Environmental Planning Commission

Agenda Number: 02
Project Number: 1003532
Case #: 16EPC-40010
April 14, 2016

Staff Report

Agent	Joe Slagle – Slagle Herr Arch.
Applicant	Robert C. & Katie Kerschen
Request	Site Development Plan for Building Permit
Legal Description	Lot 11, Block 10, Plat of lots 11-A & 22-A, Block 10 Tract 2 Unit 3, North Albuquerque Acres
Location	On Holly Ave. NE, between Louisiana Blvd. NE and Wyoming Blvd. NE, and North of Paseo del Norte
Size	Approximately 0.70 acres
Existing Zoning	SU-2/Mixed Use
Proposed Zoning	No Change

date
3-11-16
sheet
A001 EPC SHEET 1

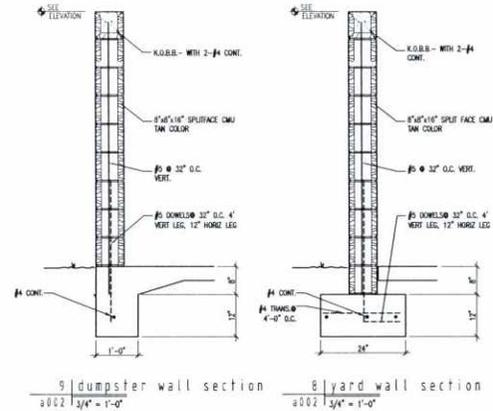
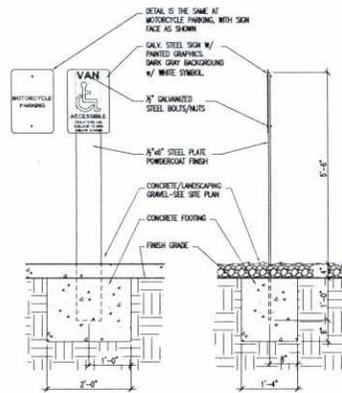
The request furthers 5.4.6 Common Design Regulations for all SU-2 Zoned Properties and Policy 8R-3 because it fulfills the patio requirement per Keyed Note 20 of Sheet A001 of the site development plan. The indicated patio square footage is listed at 200 which is greater than the required minimum of 4% or greater of the building foot print (3,391 sf / .04 = 136 sf). The applicant is not proposing a plaza.

The patio will be paved, however no furniture for outdoor seating is shown on the site development plan. While this is not required by the LCSDP Design Guidelines, staff recommends that the site development plan be revised to include outdoor furniture in order to provide an amenity for clients and staff.

2. Prior to application submittal to the DRB, the applicant shall meet with the staff planner to ensure that all conditions of approval are met.
3. The site development plan (Sheet A001) shall be revised to include outdoor furniture in the proposed patio area order to provide an amenity for clients and staff. A keyed note shall also be included identifying the outdoor furniture.

date
 2-25-16
 sheet
 L001 EPC SHEET 3

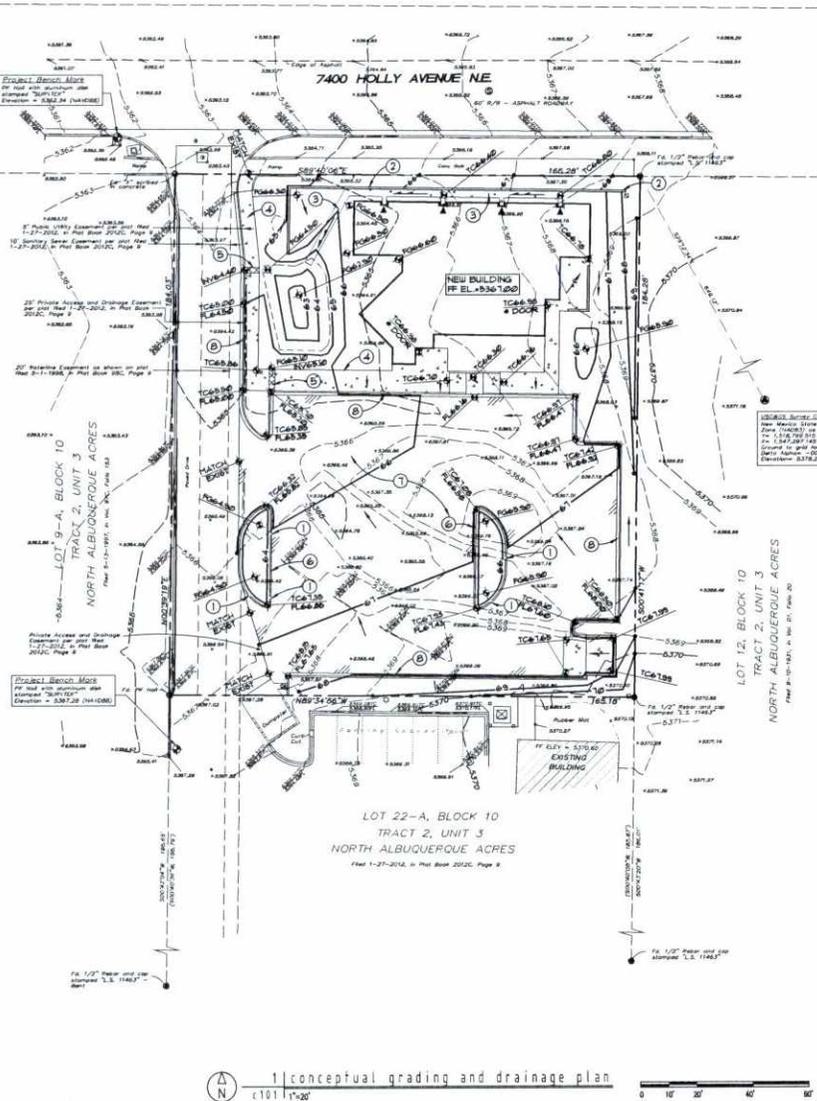
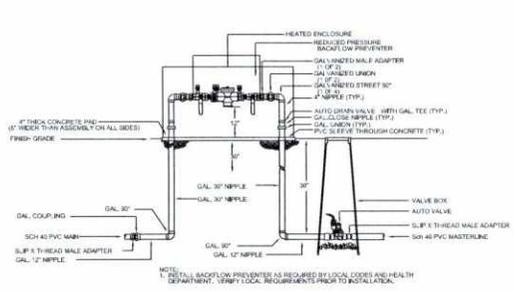
The landscaping plan contains low to medium water usage tree and plant species; all species are appropriate for the area and a plant schedule is provided. All required notations regarding maintenance responsibilities, water conservation and irrigation system to be used are included on the landscape plan. Per Section 6-6-2-5 (Street Tree Policies) of the Code of Ordinances the applicant is required to provide a street tree plan for any building of over 200 sf and where the lot is adjacent to a major street. The LCSDP indicates that the spacing shall be no more than 25' on center. The street frontage dimension along Holly Ave. is 165.28 lineal feet meaning that the minimum number of required street trees is 6, the applicant has indicated that only 4 will be provided on the landscape plan. The landscape plan will need to be revised to include 2

additional street trees. Additionally, 3 parking lot trees are required which the applicant has indicated on the landscape plan per Section 14-16-3-10(G)(1) (Special Landscaping Standards) of the Zoning Code.

5. The landscape plan shall be revised to include 2 additional street trees in order to comply with the City of Albuquerque Street Tree Ordinance (6-6-2-5, Street Tree Policies).
